ADDENDUM NO. 1
HOLBROOK MUNICIPAL AIRPORT
MARCH 20, 2024

RE: Schedule I – Reconstruct Apron
Schedule II (Non-AIP) – Reconstruct Apron Hangar Connections
AIP No. 3-04-0020-0xx-2024 | ACI No. 22965

The following Addendum shall be incorporated into the Contract Documents for the above-referenced project and shall supersede all contrary and conflicting information, which are hereby supplemented or revised in certain particulars in the following:

Sheet: 2.1

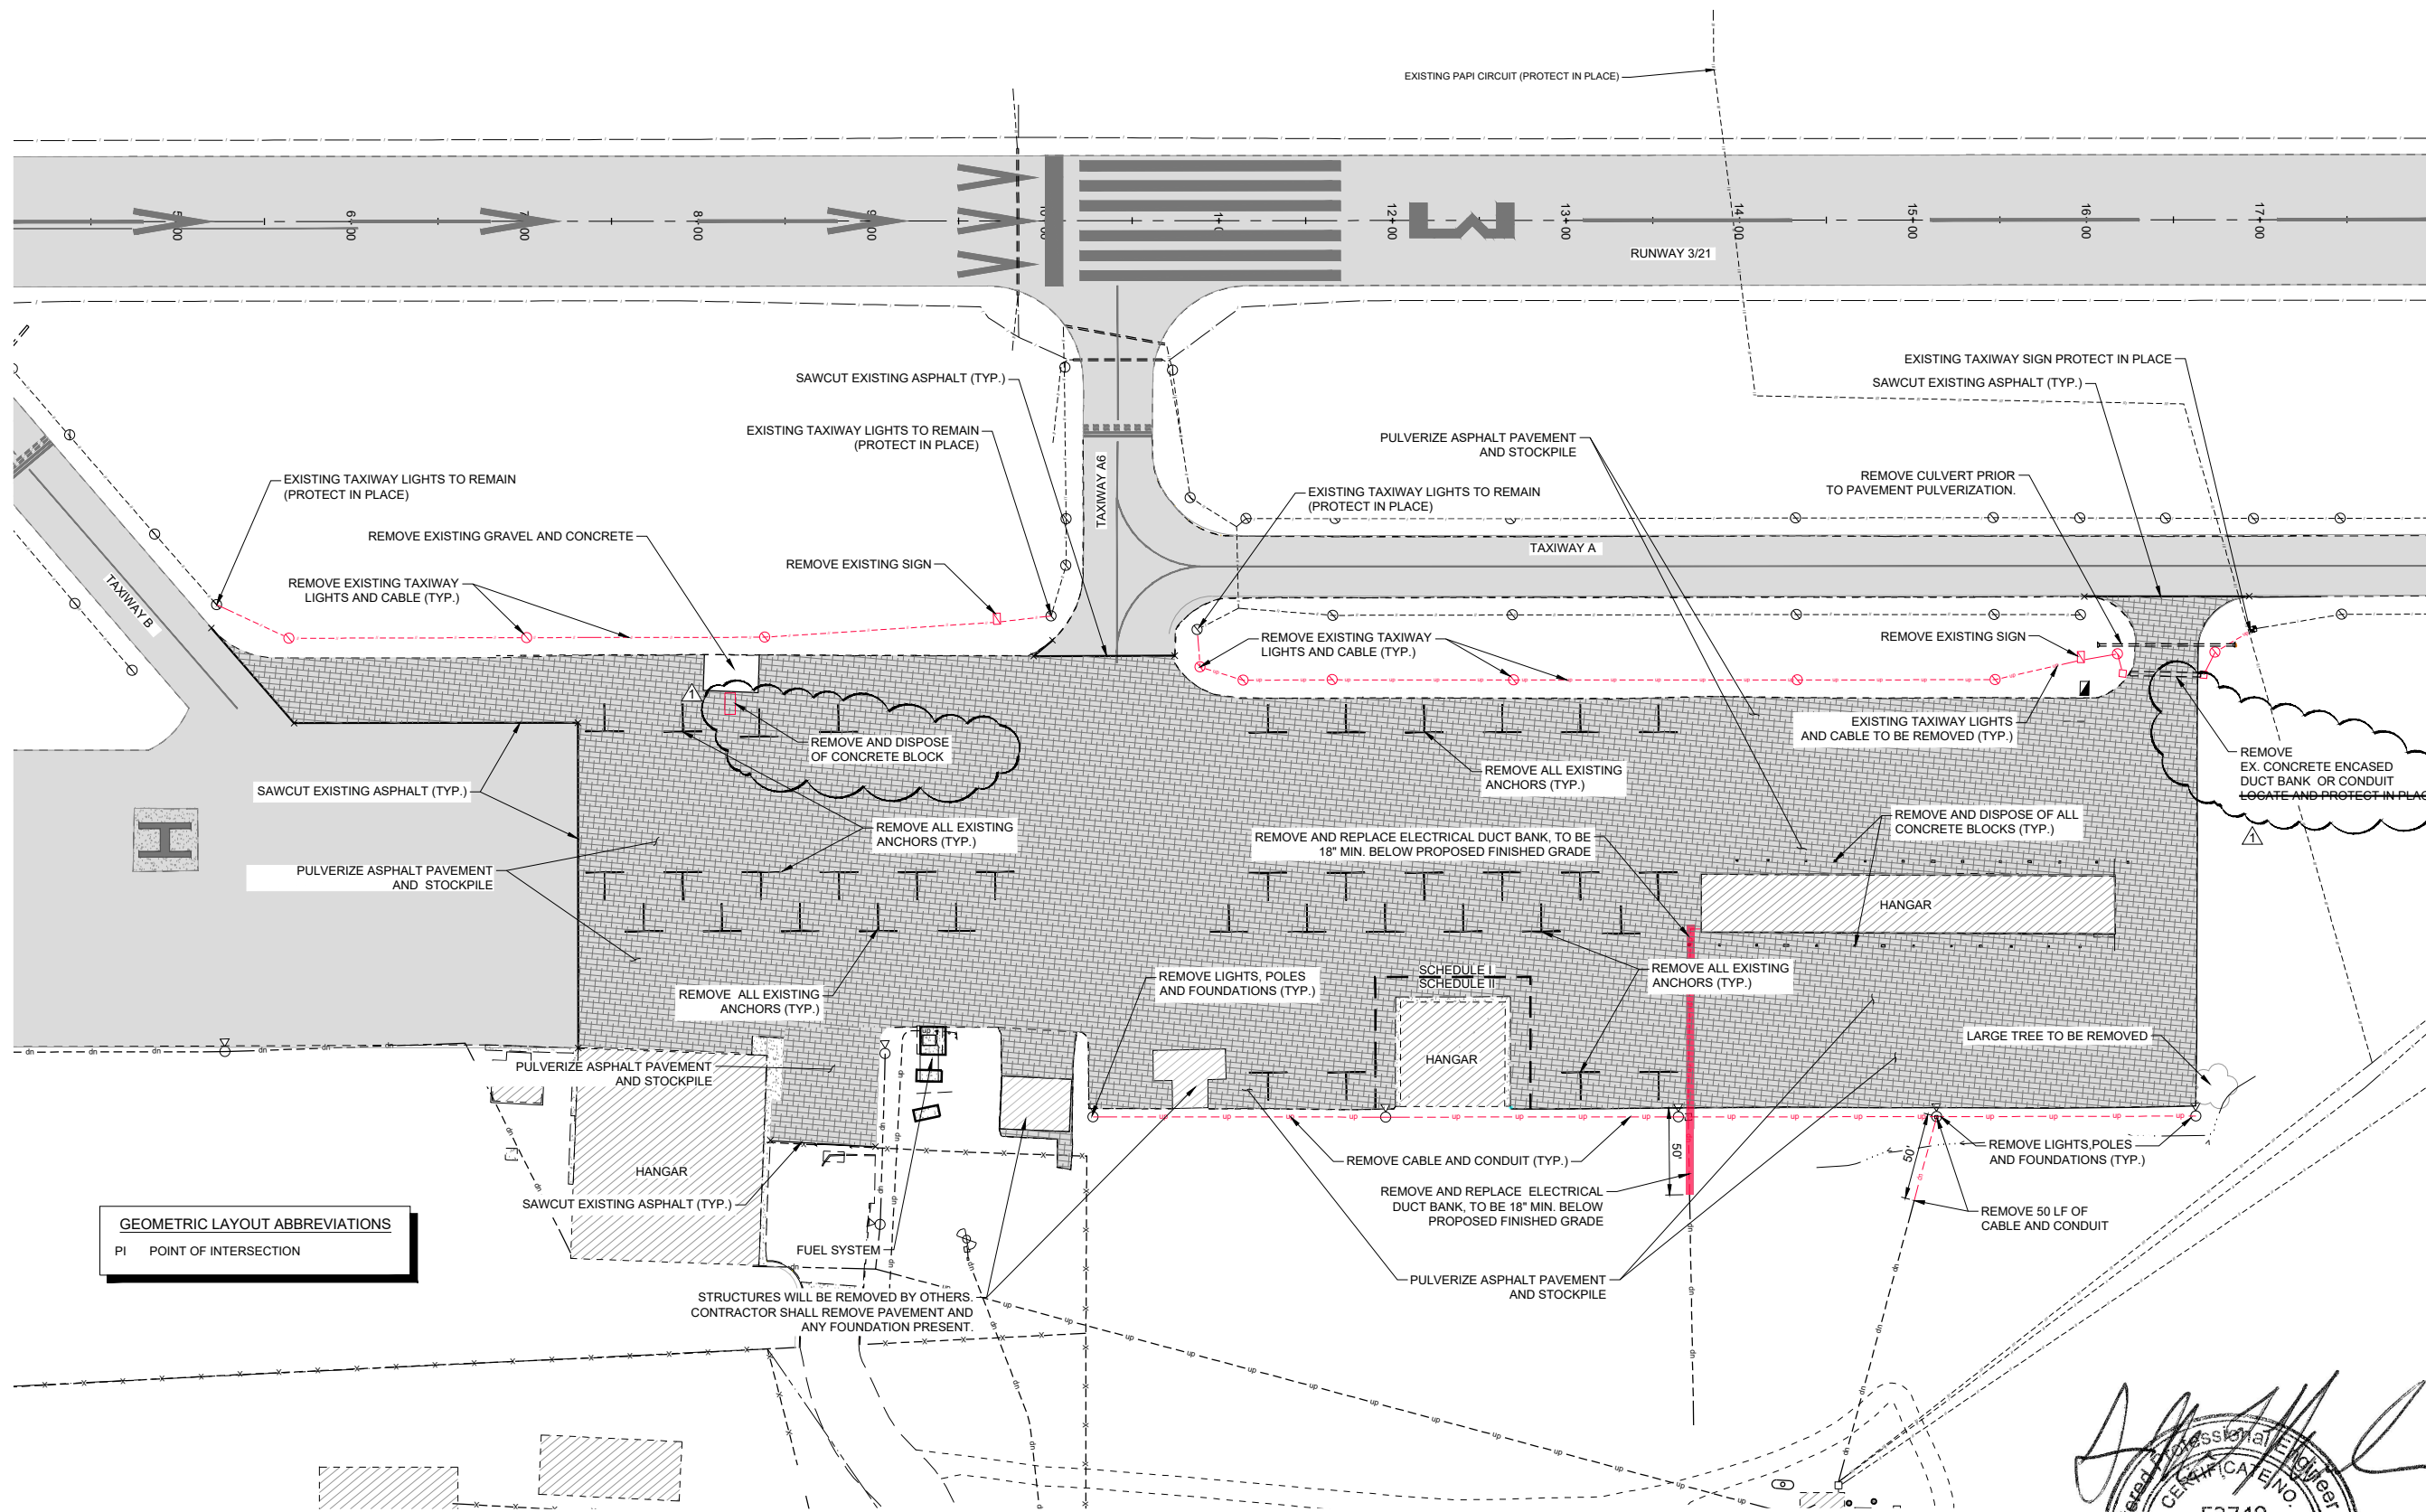
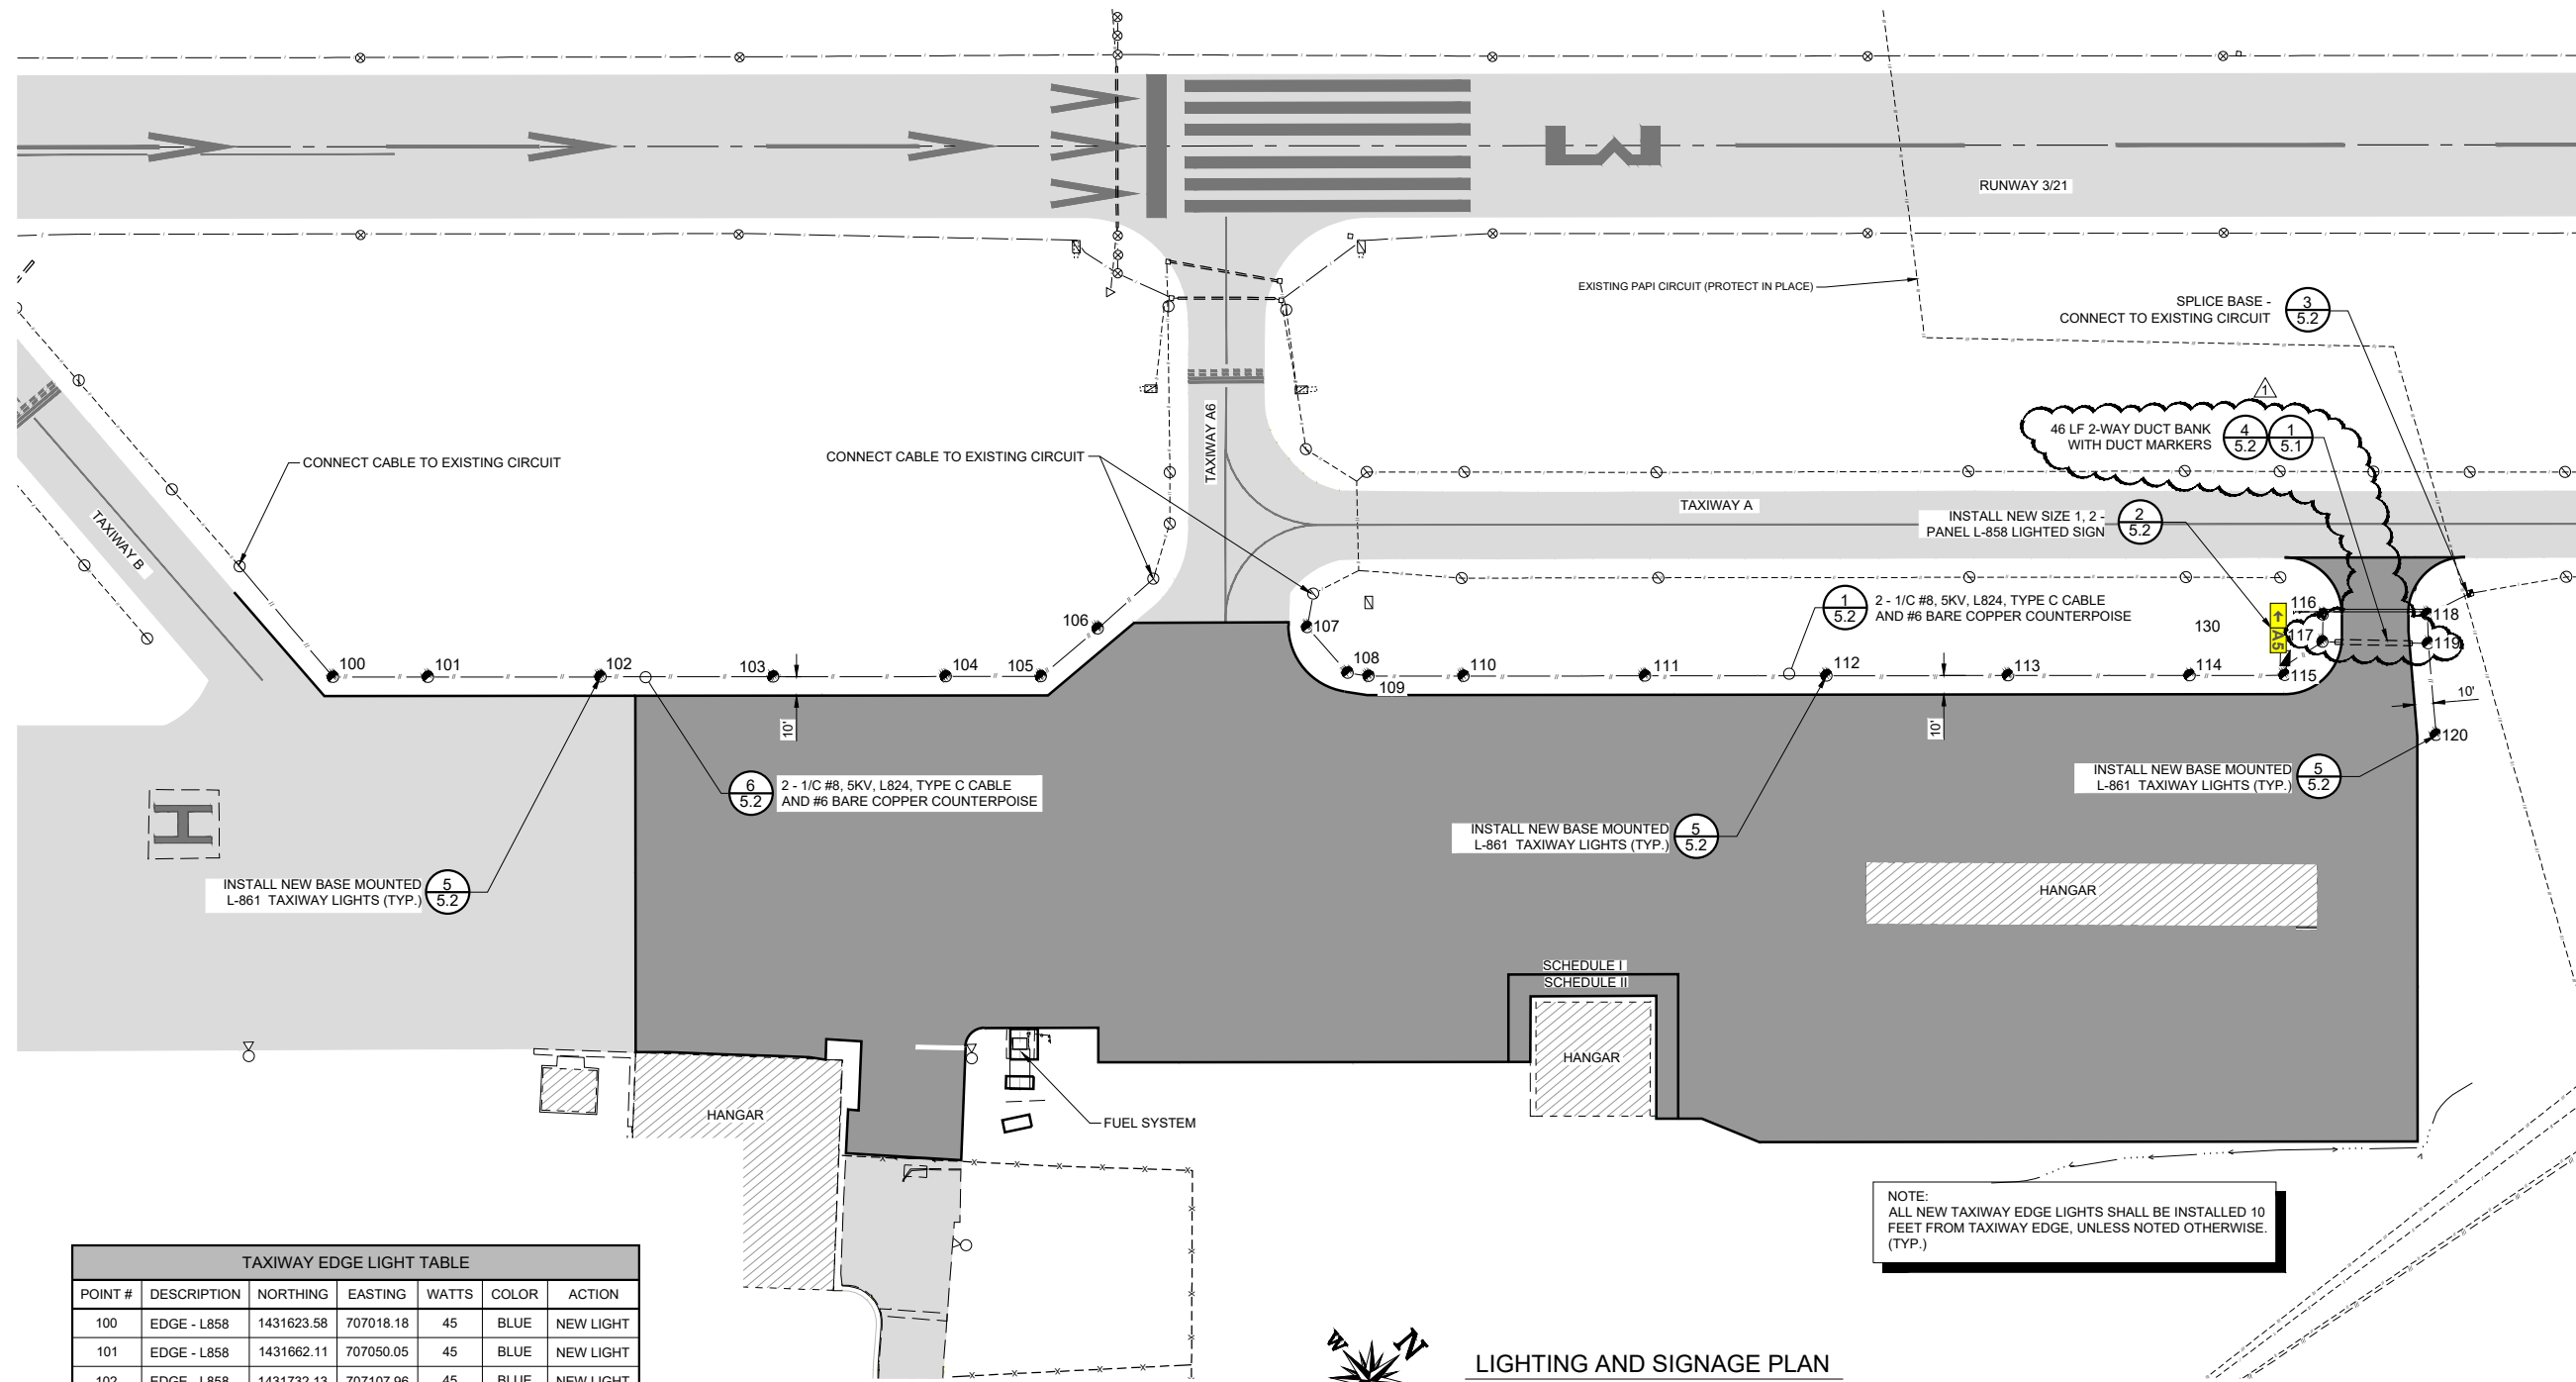
- A. **Plan Sheet 2.1.** A note has been added to callout the removal of an additional concrete block on the left half of the removal page. Another note has been altered to include the removal of the concrete encased duct bank on the right side of the removal sheet. Changes have been clouded on the attached revised Sheet 2.1.
- B. **Plan Sheet 5.1.** A leader arrow has been added to the callouts for the proposed concrete encased duct bank located on the right side of the sheet as well as adjusting lights 117 and 119 to correspond to the duct bank location. Changes have been clouded on the attached revised Sheet 5.1.

- Q.)** Item P-101d Removal of Concrete Structures is measured by lump sum. How many concrete blocks will be removed under this item.
- A.)** There is approximately 35 small concrete structures to be removed in the apron reconstruction area. No additional payment will be provided for any additional concrete structures discovered during construction. These concrete structures are noted on plan sheet 2.1 and noted during the pre-bid site walk.
